# HISTORIC AND DESIGN REVIEW COMMISSION

January 15, 2020

**HDRC CASE NO:** 2019-753  
**ADDRESS:** 217 CEDAR ST  
**LEGAL DESCRIPTION:** NCB 2963 BLK 11 LOT N 52.52 FT OF 1  
**ZONING:** RM-4  
**CITY COUNCIL DIST.:** 1  
**DISTRICT:** King William Historic District  
**APPLICANT:** QUINN DENNIS C & CHEEVER JOAN M  
**OWNER:** QUINN DENNIS C & CHEEVER JOAN M  
**TYPE OF WORK:** Front porch railing installation  
**APPLICATION RECEIVED:** December 20, 2019  
**60-DAY REVIEW:** February 18, 2020  
**CASE MANAGER:** Rachel Rettaliata  
**REQUEST:**

The applicant is requesting a Certificate of Appropriateness for approval to install a railing on the front porch.

RAILING ELEVATION

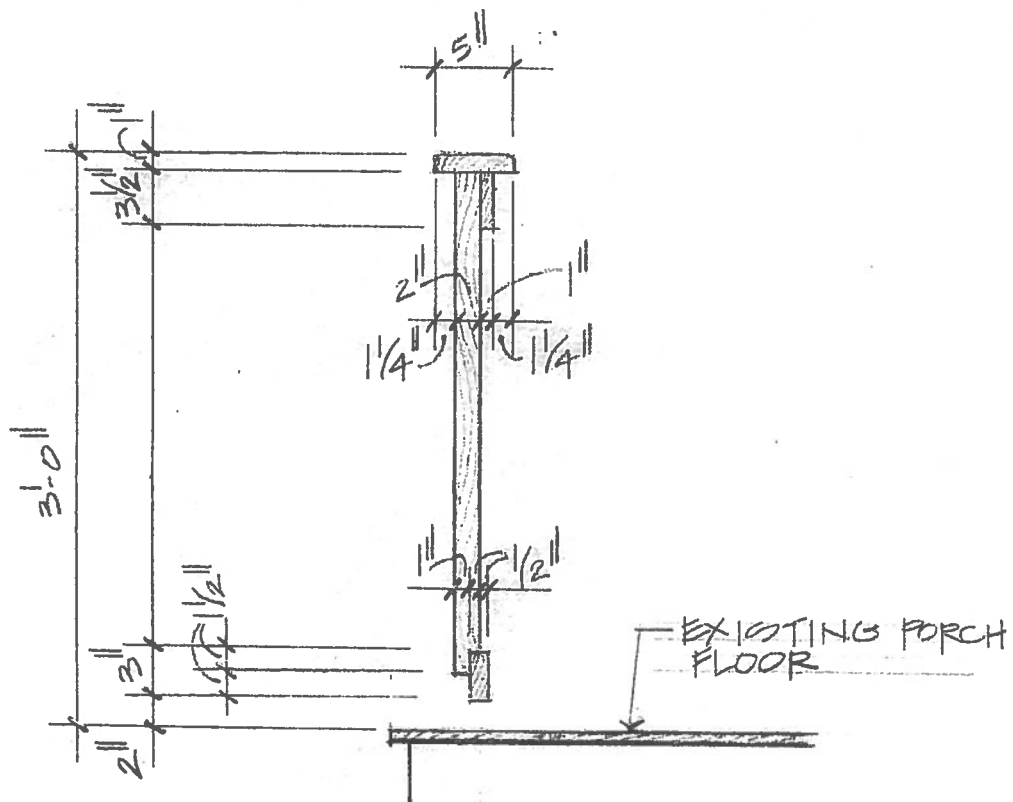
- a. The primary structure located at 217 Cedar was constructed circa 1910 in the Folk Victorian Style. The structure features a modified L-plan, a wraparound porch, a brick chimney, a standing seam metal roof, and two street facing entrances. The property is contributing to the King William Historic District.
- b. **PORCH RAILING: MATERIAL AND DESIGN** – The applicant has proposed to install a wood railing on the front porch that will span the wraparound porch and flank the existing porch stairs. The proposed railing is a

simplified design. Guideline 7.B.iv for Exterior Maintenance and Alterations stipulates that replacement or new elements should be simple in design so as to not distract from the historic character of the building. Staff finds the proposal consistent with the Guidelines.

Staff recommends approval of the front porch railing installation based on findings a through b.
